# Access Compliance Report

## Public Rights-of-Way (Curb Ramps)

Intersection ID: 2587	Main Street: KILMARTIN_LN	Cross Street: MCCHESENEY_DR	Location: S
ADA ID: 16C633AB00D3	Ramp Type: PerpDiag	Initial Pass/Fail: Pass	Overall Compliance: No Severity Score: 17.75

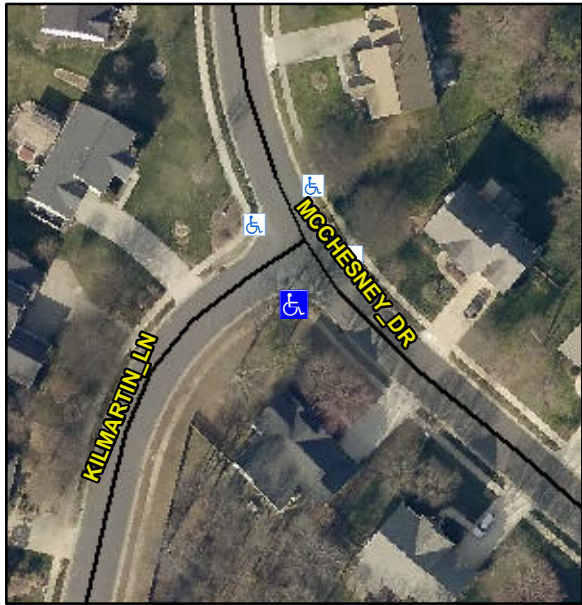
Codes/Mitigation Info/Possible Solution			Field Measurements/Component Compliance					
	Possible Solutions:		Compliance	Description	Data	Compliance	Description	Data
	Remove & Replace Curb Ramp With Two New Directional Ramps or Equivalent. Remove & Replace Gutter.		N/A	Ramp Length (in)	46.0	Yes	Ramp Slope (%)	6.5
			Yes	Ramp Width (in)	48.0	No	Ramp XSlope (%)	3.5
			N/A	Flare Type LT	Sloped	N/A	Flare Type RT	N/A
			N/A	Flare Slope LT (%)	1.4	Yes	Flare Slope RT (%)	3.8
			N/A	Flare Traversable LT?	Yes	N/A	Flare Traversable RT?	Yes
			Yes	Landing Length (in)	48.0	No	DWS Provided?	No
			Yes	Landing Width (in)	55.0	N/A	DWS Contrast?	No
			Yes	Landing Slope (%)	0.4	N/A	DWS Length (in)	N/A
			No	Landing X Slope (%)	4.0	N/A	DWS Full Width?	No
Surveyor Notes:		N/A	N/A	Landing Curb? (Y/N)	No	N/A	DWS Offset (in)	N/A
PROW/ADA:		Not Found, R304.5.3, R305, R302.7.2	N/A	Shared Landing?	No			
			Yes	Gutter Ponding?	No	Yes	Gutter Slope (%)	0.1

No	Gutter Lip Ht (in)	0.5	No	Gutter X Slope (%)	2.1
			N/A	Painted X Walk1?	No	N/A	Painted X Walk2?	No
				X Walk 1 Direction	To E		X Walk 2 Direction	To N
			N/A	X Walk 1 Width (in)	N/A	N/A	X Walk 2 Width (in)	N/A
				X Walk 1 Slope (%)	1.8		X Walk 2 Slope (%)	2.6
				X Walk 1 X Slope (%)	1.5		X Walk 2 X Slope (%)	1.2
			N/A	Ramp inside XWalk1?	N/A	N/A	Ramp inside XWalk2?	N/A
				Road Slope (%)	2.0	N/A	Clear Space?	Yes
				Road X Slope (%)	3.0	N/A	Clear Space to XWalk (in)	N/A
			Yes	Any Obstructions?	No	Yes	Storm Grate/Utility Hazard?	No
				Obstruction Type			Storm Grate/Utility Type	
					N/A			N/A
						Yes	Surface Condition? (G/P)	Good
Total Cost:		\$ 3950.00
